Intel[®] Mobile Celeron[™] Processor at 550 MHz, 500 MHz, 450 MHz, and 400A MHz Specification Update

Release Date: April 2000

Order Number: 245421-003

Figure 6. BCLK Timing Waveform

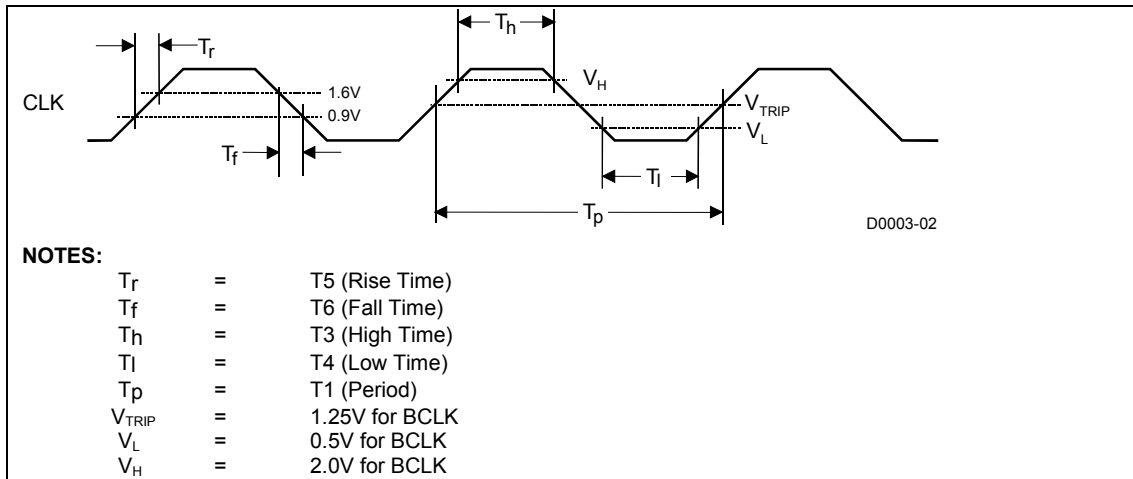
For B0 step processors, the $V_{IH,BCLK}$ Min spec is changed to 2.0V (from 1.7V for A2 step) and $V_{IL,BCLK}$ Max spec is changed to 0.5V (from 0.7V for A2 step). Due to this, new values are specified for BCLK high and low times for B0 step processors. These modifications affect corresponding specs in Table 12, Table 13, Table 22, and Figure 6 in *Mobile Celeron™ Processor in BGA2 and Micro-PGA2 Packages at 500 MHz, 450 MHz, and 400A MHz* datasheet.

The following tables and figures highlight the above mentioned BSEL[1:0] and BCLK specs modifications made for B0 step processors:

Symbol	Parameter	Min	Typ	Max	Unit	Figure	Notes
	System Bus Frequency		100		MHz		
T1	BCLK Period		10		ns	Figure 6	Note 2
T2	BCLK Period Stability			± 250	ps		Notes 3, 4
T3	BCLK High Time	2.70			ns	Figure 6	at >2.0V
T4	BCLK Low Time	2.45			ns	Figure 6	at <0.5V
T5	BCLK Rise Time	0.175		0.875	ns	Figure 6	(0.9V – 1.6V)
T6	BCLK Fall Time	0.175		0.875	ns	Figure 6	(1.6V – 0.9V)

Figure 4. BCLK Waveform at the Processor Core Pins

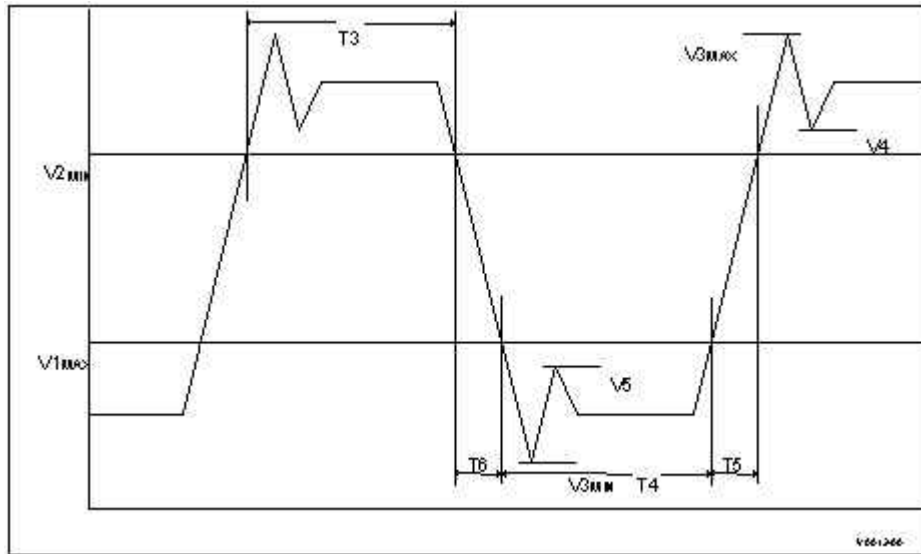
In Table 18, “BCLK Signal Quality AC Specifications at the Processor Core” of the *Intel® Celeron™ Processor Mobile Module: Mobile Module Connector 2 (MMC-2) at 500 MHz and 450 MHz Datasheet*, Note 3 has changed. Figure 4 “BCLK Waveform at the Processor Core Pins” has also been updated. See below.

- The rising edge ringback voltage specified is the minimum absolute voltage that the BCLK signal can dip back to after the BCLK signal passes the $V_{IH,BCLK,MIN}$ (rising) voltage limits. The falling edge ringback voltage specified is the maximum absolute voltage that the BCLK signal can dip back to after the BCLK signal passes the $V_{IL,BCLK,MAX}$ (falling) voltage limits.
